URBAN DESIGN COMMISSION APPLICATION CITY OF MADISON

1. **Project Address:** 510 University Avenue

Project Title (if any): Hub at Madison II

The Hub at Madison II -UDC RE-SUBMITTAL

Drawing Title: **UNIVERSITY AVE ELEVATION**

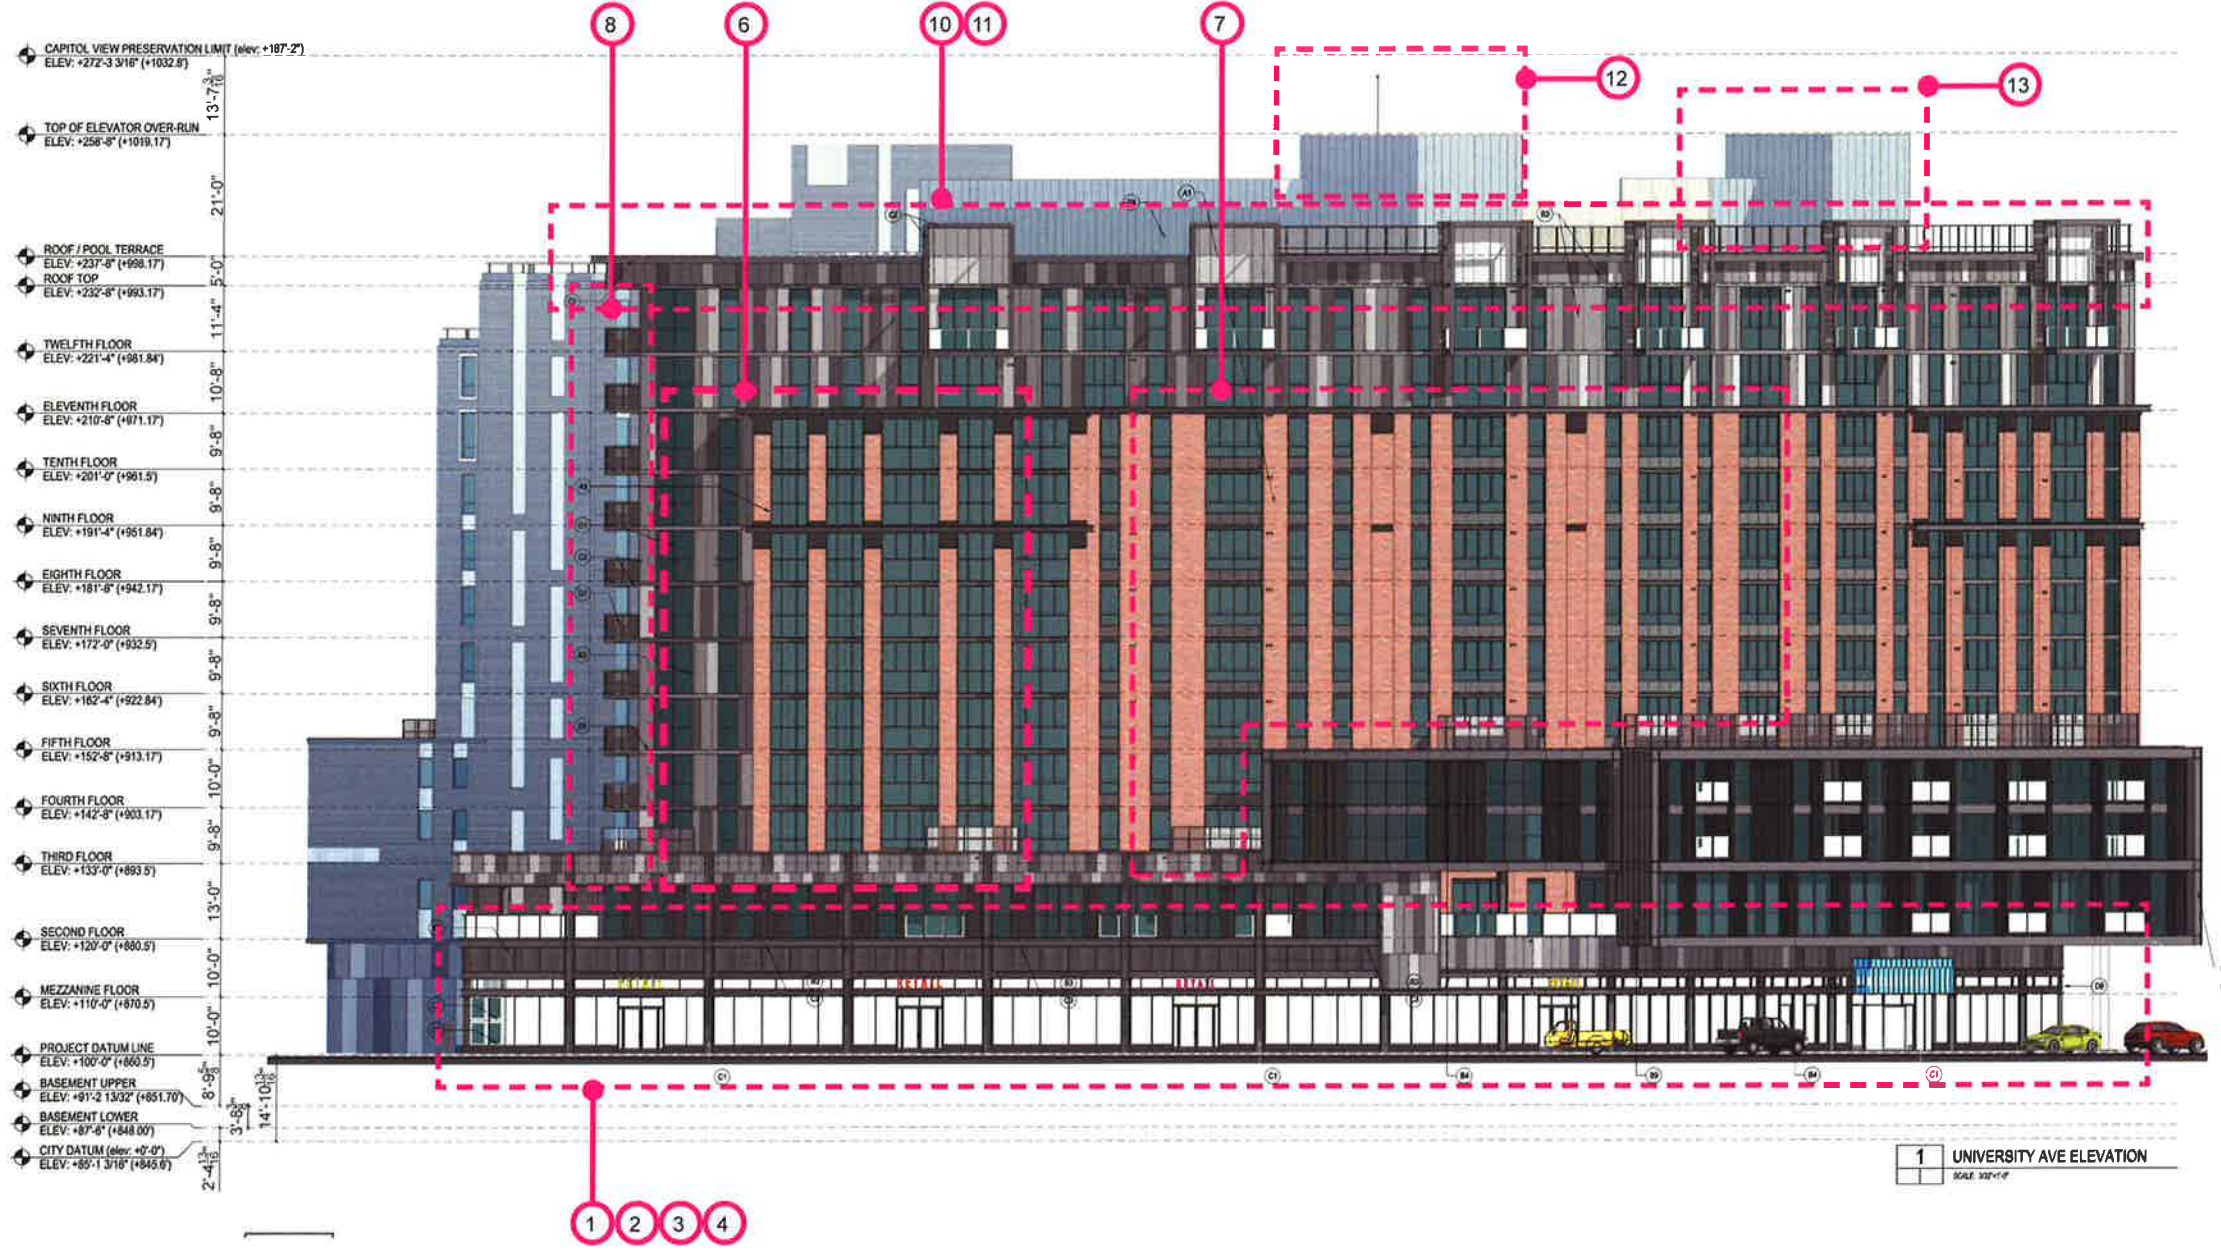
1. Brick knee wall added at University Ave. / Gorham St. storefront.
2. Residential and leasing lobby entry and canopies reduced from three to one. Film at lobby entry doors remove. Lobbies rationalizes into one connected space eliminating need for 3 entries. Canopy over entry redesigned to match cladding concept.

3. Storefront subdivisions simplified. Staggered pattern to match metal panel pattern.
4. Corner of University and alleyway revised to reflect change at fire rated vision triangle sightlines.

11. Glass Pool terrace screen scope reduced. Pool terrace size reduced.
12. Multiple lighting masts centralized in single mast to rear of lift overrun.
13. Second elevator overrun added.

14. Exhaust grills enlarged above garage door and entry glazing reduced accordingly. Mechanical requirement
15. Black brick cladding at street. Replace CMU and stucco cladding at street.

16. CMU & stucco podium walls changes to scored CMU and patterned paint finish. Changed for constructability and maintenance issues. 16A change: CMU & stucco wall changed to concrete shear wall with reveal lines and patterned paint finish.

17. Garage door colors simplified to 1 color plus glass.
18. Scuppers added at terraces. Flood prevention.
19. Vision glass added. Spandrel panel glass replaced.

20. Planting removed from roof on 8th floor. Maintenance access not possible through slider windows.
21. Window location altered.
22. Mechanical screen height increased from 20' to 23'-6"

23. Mechanical exhaust/intake grills. Mechanical vent requirements.
24. Brick clad columns changed to natural finish columns.
25. Fire rated windows added. At share light well to neighbor.

26. Brick knee wall remove from metal panel areas.
27. Windows removed. Plan changes, windows no longer possible.
28. Door type change. Size reduced to suit exterior space plan.

DRAWING TITLE: GORHAM STREET ELEVATION

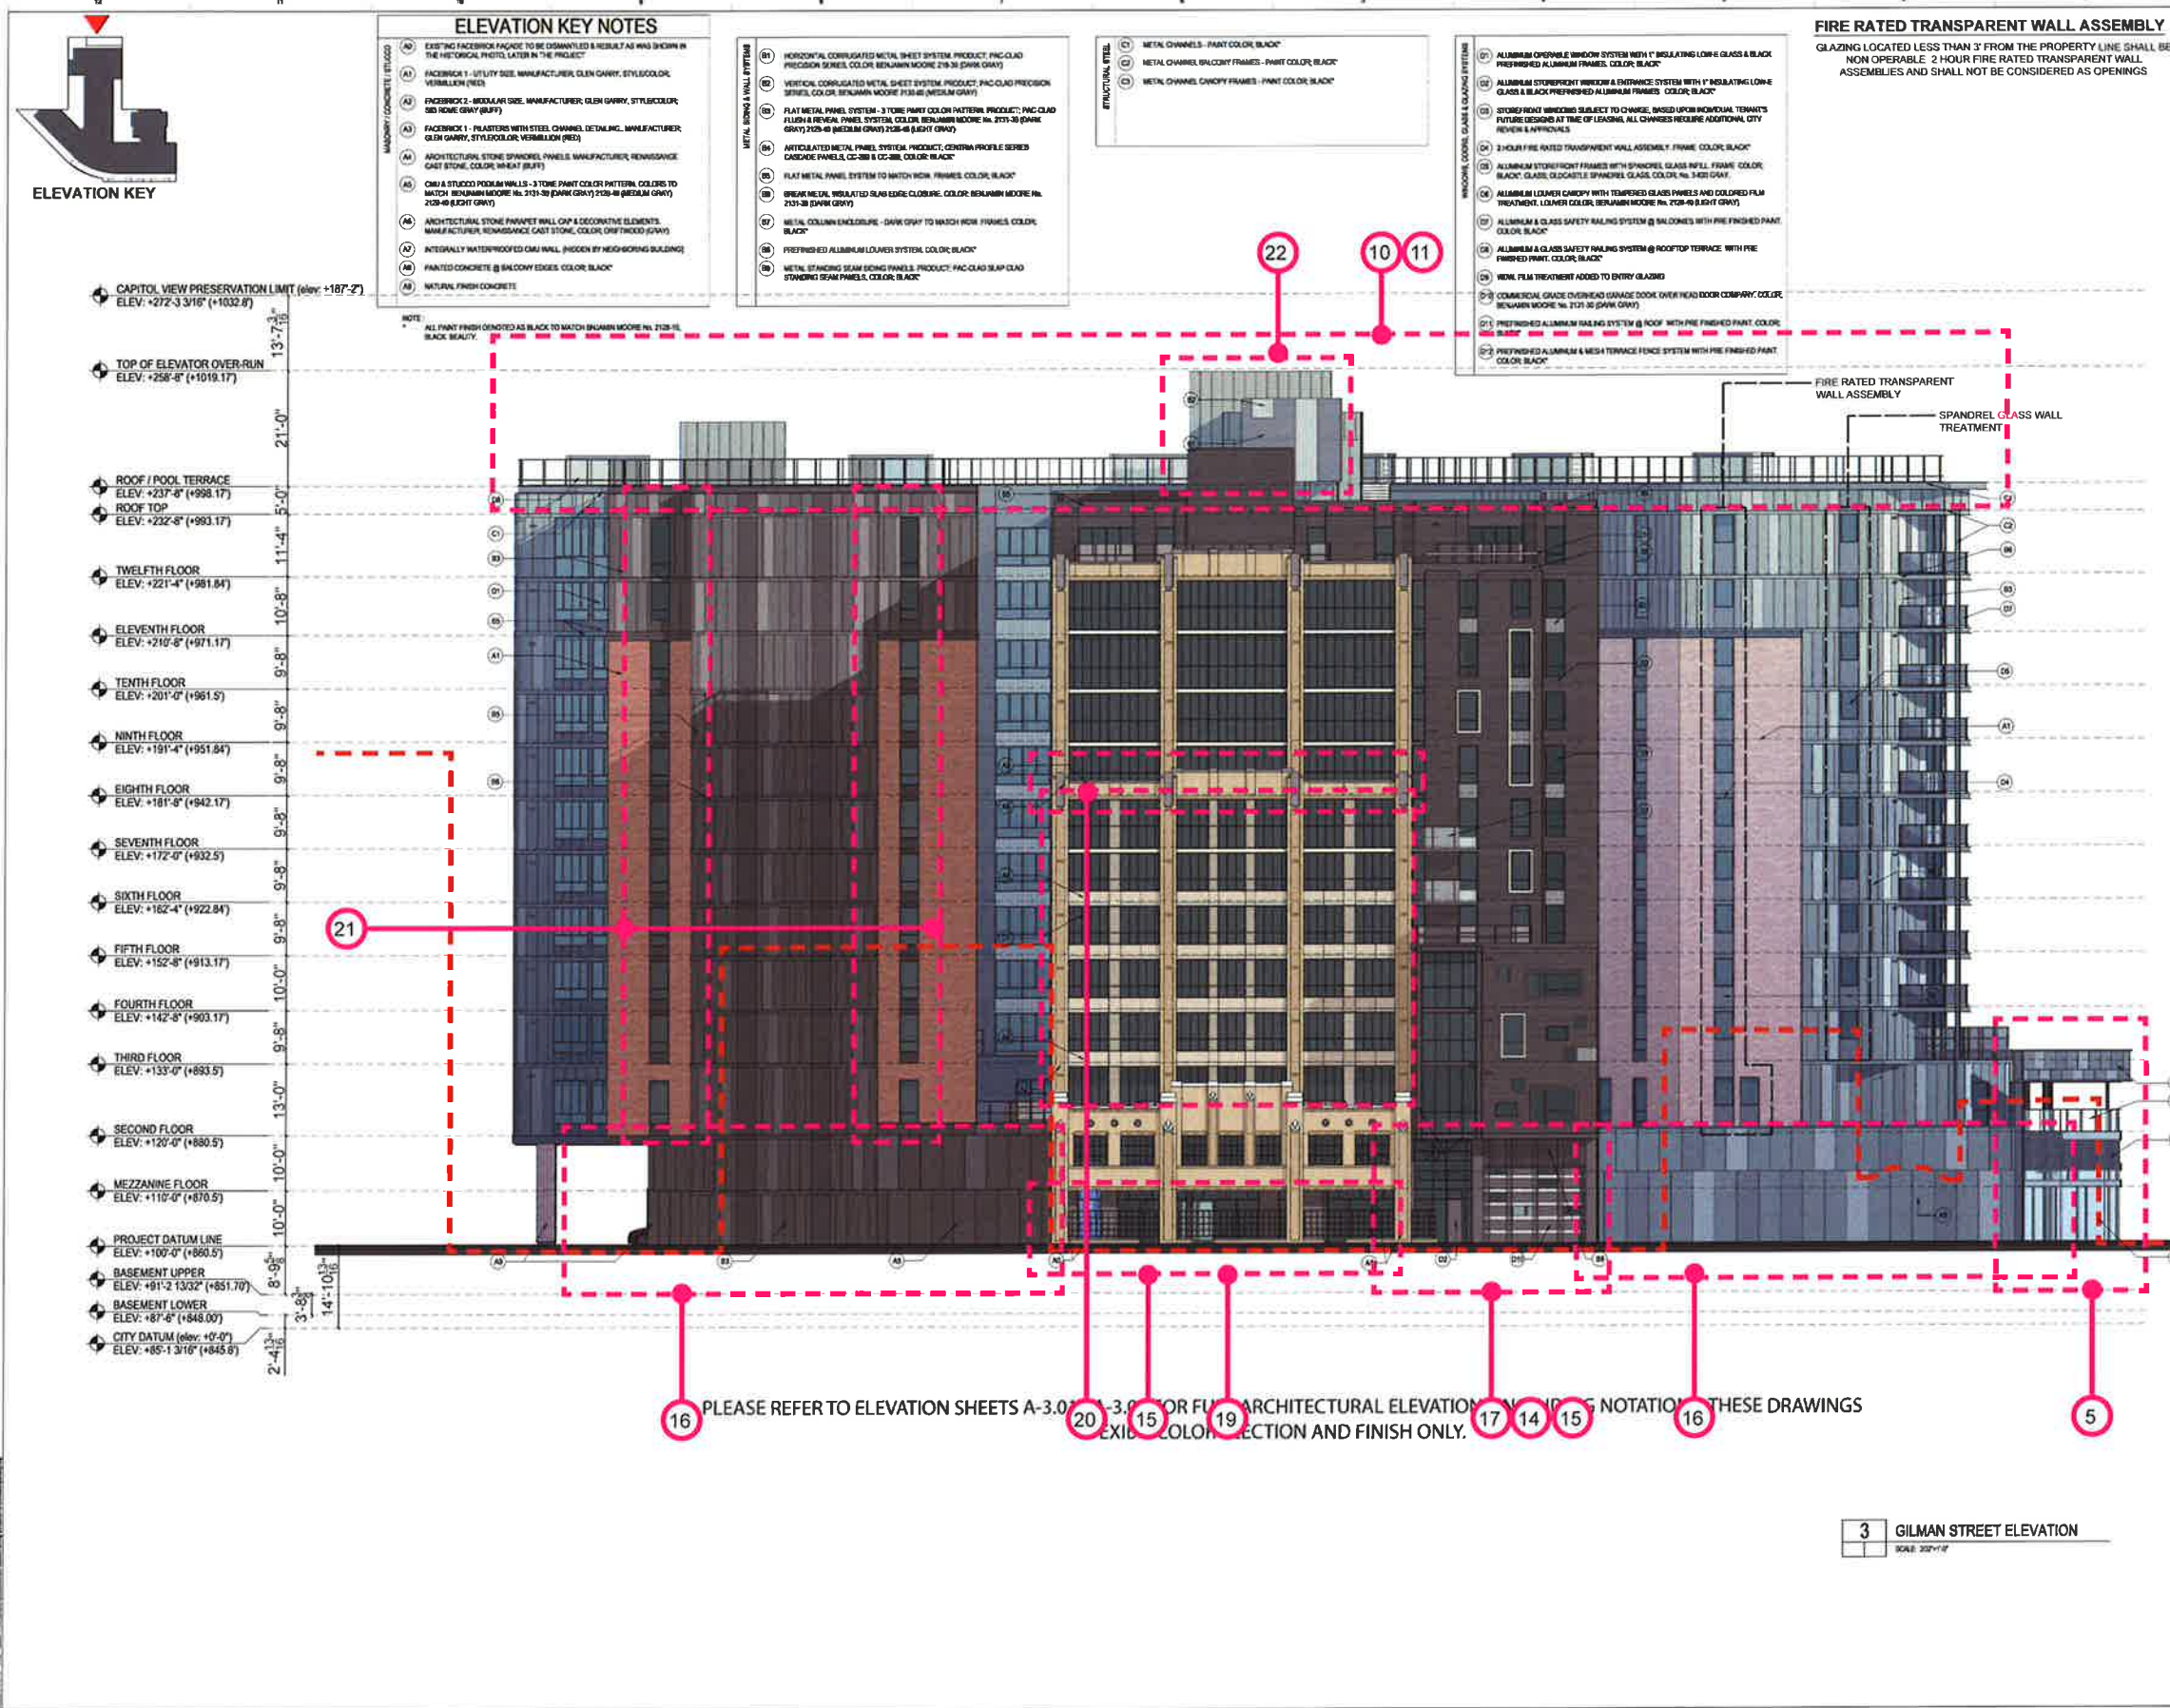
1. Brick knee wall added at University Ave. / Gorham St. storefront.
2. Residential and leasing lobby entry and canopies reduced from three to one. Film at lobby entry doors remove. Lobbies rationalizes into one connected space eliminating need for 3 entries. Canopy over entry redesigned to match cladding concept.

3. Storefront subdivisions simplified. Staggered pattern to match metal panel pattern.
4. Corner of University and alleyway revised to reflect change at fire rated vision triangle sightlines.

11. Glass Pool terrace screen scope reduced. Pool terrace size reduced.
12. Multiple lighting masts centralized in single mast to rear of lift overrun.
13. Second elevator overrun added.

14. Exhaust grills enlarged above garage door and entry glazing reduced accordingly. Mechanical requirement
15. Black brick cladding at street. Replace CMU and stucco cladding at street.

16. CMU & stucco podium walls changes to scored CMU and patterned paint finish. Changed for constructability and maintenance issues. 16A change: CMU & stucco wall changed to concrete shear wall with reveal lines and patterned paint finish.

17. Garage door colors simplified to 1 color plus glass.
18. Scuppers added at terraces. Flood prevention.
19. Vision glass added. Spandrel panel glass replaced.

20. Planting removed from roof on 8th floor. Maintenance access not possible through slider windows.
21. Window location altered.
22. Mechanical screen height increased from 20' to 23'-6"

23. Mechanical exhaust/intake grills. Mechanical vent requirements.
24. Brick clad columns changed to natural finish columns.
25. Fire rated windows added. At share light well to neighbor.

26. Brick knee wall remove from metal panel areas.
27. Windows removed. Plan changes, windows no longer possible.
28. Door type change. Size reduced to suit exterior space plan.
